JAPAN ENGINE CORPORATION

Subject : Procedure for setting and decreasing of cylinder lubricating oil feed rate after renewing of a cylinder liner and piston rings	Application	UEC Diesel Engine
	Type	All UEC
	No.	USI-10009E
If necessary

Procedure for Increasing Speed
after Renewing Piston Ring and Cylinder Liner

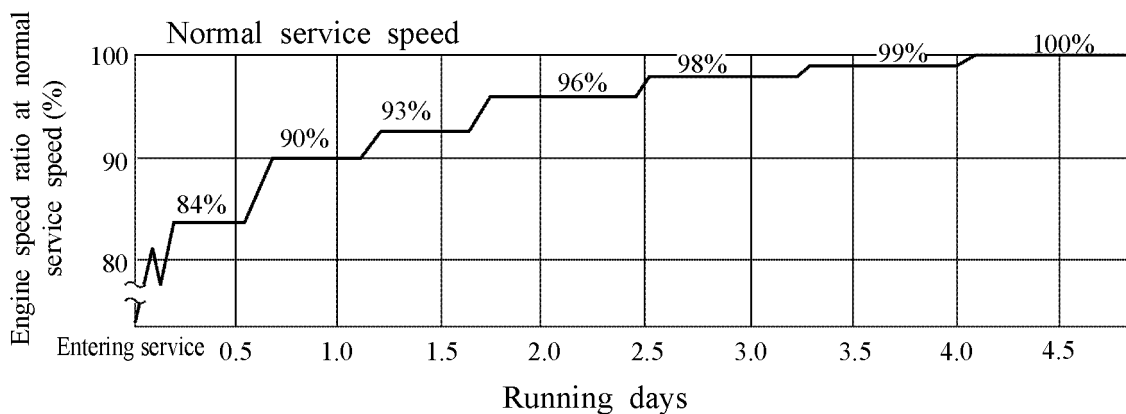
When an engine is run after renewing the piston ring or the cylinder liner, a running-in period must be given. Referring to the following procedure for increasing speed, increase engine speed step by step. In addition, cylinder oil feed amount of the cylinder in question must be increased.

1. This chart will serve as reference for a procedure for increasing speed after renewing the piston ring or the cylinder liner. Therefore, in case of an actual voyage, a decision is to be made in accordance with the conditions of various parts of the engine.
2. The range of critical speed due to torsional vibration shall be passed through as soon as possible.

1. Cylinder oil feed rate of the cylinder in question shall be increased more than before renewing.
2. If cylinder liner and piston ring were replaced, increase to amount of running hour 0 (h) of Fig.1. Guidance of the cylinder oil feed rate of 053-02, and then decrease according to the guidance.
3. If piston ring alone were replaced, increase for +0.2g/PSh more than cylinder oil injection rate before replacement of piston ring (Max. 1.3g/PSh).
After running for 200~300 hours, examine the conditions of cylinder liner and piston ring, when the results are acceptable, the feed rate can be reduced down [max. approx. 0.07 g/kWh (0.05 g/PSh) for a step] to normal value step by step.
